PLANNING & DEVELOPMENT ADVISORY COMMITTEE
VIRTUAL MEETING BY ELECTRONIC PARTICIPATION &
IN-PERSON AT THE PUSLINCH COMMUNITY CENTRE –
23 BROCK RD S, PUSLINCH
MARCH 14, 2023
7:00 p.m.

7.1 Minor Variance Application D13-COA – Brian Coady and Angelina DeLeo – 7262 Gore Road, Concession Gore S, Part Lot 29, Township of Puslinch. **≠**

PLANNING REPORT
for the TOWNSHIP OF PUSLINCH

MEETING DATE:	March 14th, 2023
TO:	Lynne Banks, Development and Legislative Coordinator Township of Puslinch
FROM:	Joanna Salsberg, Planner County of Wellington
SUBJECT:	**MINOR VARIANCE APPLICATION D13/COA (Brain Coady)** **7262 Gore Road,** **PUSLINCH CON GORE S PT LOT;29 RP 61R11232 PART 1**
ATTACHMENTS:	**1 – Submitted Site Plan**

ATTACHMENT 1: Submitted Site Plan

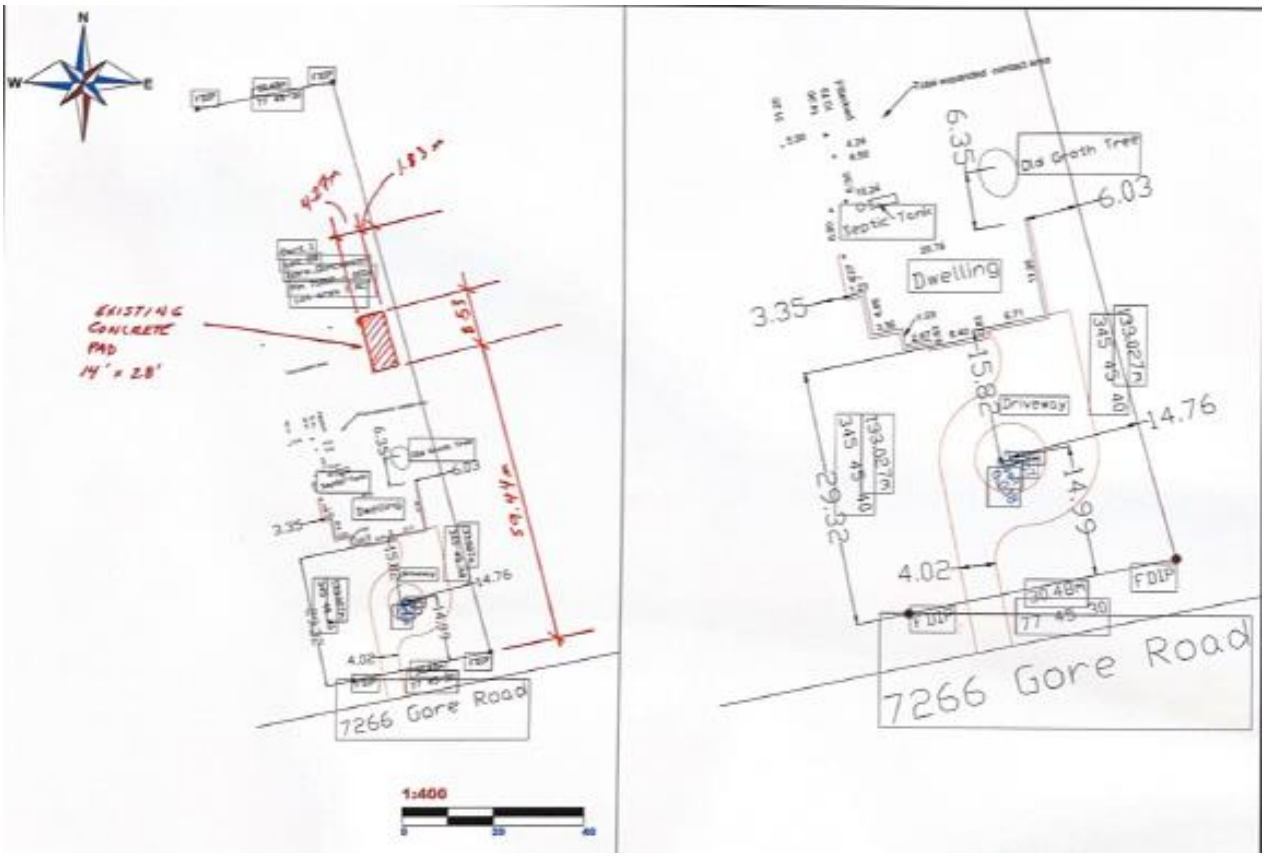
The applicant is proposing to construct an accessory structure (garden shed) on the subject property on an existing concrete pad. The variance requested would provide relief from Section 4.4.2, Table 4.1. of the Zoning By-law requesting permission for a decrease in the interior side yard setback (right). The applicant has advised that the concrete pad, on which a future garden shed is proposed to be constructed, was installed 1.83 m (6.0 ft) from the interior side yard, whereas the by-law requires a minimum interior side yard setback 2 m (6.6 ft). When constructed, the garden shed would not meet the 2 m (6.6 ft) setback requirement.

The minor variance application would maintain the general intent and purpose of the Official Plan and Zoning By-law, and is desirable and appropriate for the development of the subject property provided any concerns of the Building and Public Works Departments are addressed including adequate servicing, as well as drainage and grading. We consider the request minor and have no concerns with the application.

Four Tests	Discussion
That the requested variance is **minor** in nature	• The subject lands contain an existing dwelling and a concrete pad. The applicant is proposing to construct a garden shed on the existing pad. • The relief is requested is to allow for the construction of the 36.42 m^2 (392.02 ft^2) garden shed on an existing concrete pad, which would result in the shed being located to close to the interior lot line (right). • An interior side yard setback of 1.83 m (6.0 ft) is proposed for the garden shed, whereas the by-law requires a minimum interior side yard setback 2 m (6.6 ft) • The garden shed will be located to the rear of the existing residential dwelling. It appears that there is partial visual screening from the shed location to adjacent properties due to the location of existing trees on the subject lands and the abutting lands. • We would consider the variance minor in terms of impact and context with the surrounding neighbourhood.

That the intent and purpose of the **Zoning By-law** is maintained	• The subject property is located within Agricultural (A) Zone. • A single detached dwelling is a permitted use within the A Zone. Accessory uses are also permitted in accordance with the requirements of section 4.4. • Section 4.4.2, Table 4.1 of the Zoning By-law requires an interior side yard setback (right) of 2.0 m for the accessory structure. • The applicant is proposing to construct an accessory structure of 36.42 m^2 (392.02 ft^2) on a concrete pad that has already been installed. Once constructed

on the pad, the garden shed would be located too close to the interior side yard lot line. • The intent of requiring a minimum interior side yard setback is to ensure that drainage can be addressed adequately on the subject property, to allow for unencumbered movement between the front and rear yard of the property, to allow for access and maintenance of the entire parcel including private septic systems, and to create a sense of consistency within the surrounding neighbourhood. • The proposed shed meets all the other applicable requirements for accessory buildings within Table 4.1. • The proposal meets all other requirements of the A Zone. Township staff have advised that the subject property will have total a lot coverage of 6.3% with the proposed shed. The A Zone allows for a maximum of 30% lot coverage.
That the general intent and purpose of the **Official Plan** is maintained	• The subject property is designated as Secondary Agricultural within the County of Wellington Official Plan. • Single detached homes are permitted within the Secondary Agricultural Designation.

That the variance is **desirable** and **appropriate** development and use of the land, building or structure	• The subject lands are immediately surrounded by rural residential uses to the east and west, and a resort commercial use (Emerald Lake) to the north and east, and appears to have open space uses to the south in the City of Hamilton • The abutting rural residential parcels are characterized by varied lots sizes and widths. • The variance would facilitate construction of an garden shed on an existing concrete pad. Due to the location of the pad, the shed would be located too close to the interior side yard lot line (right). • The proposed reduction in the interior side yard (right) will still maintain sufficient setback for access for the maintenance of the property. • From the aerial maps it appears that there is partial visual screening from the proposed addition to adjacent properties due to the location of existing trees on the subject lands and abutting properties. • The location of the garden shed is setback considerably from Gore Road. • The Committee should consider comments received from the Public Works Department and Building Department regarding any concerns regarding site grading or drainage or servicing.

In conclusion, planning staff is of the opinion that the requested variance application meets **the four tests of the Planning Act** provided that any proposed changes to the servicing as well as grading and drainage are acceptable to the Building and Public Works Departments. We trust that these comments will be of assistance to the Committee in their consideration of this matter. We would appreciate a copy of the Committee's decision with respect to this application.
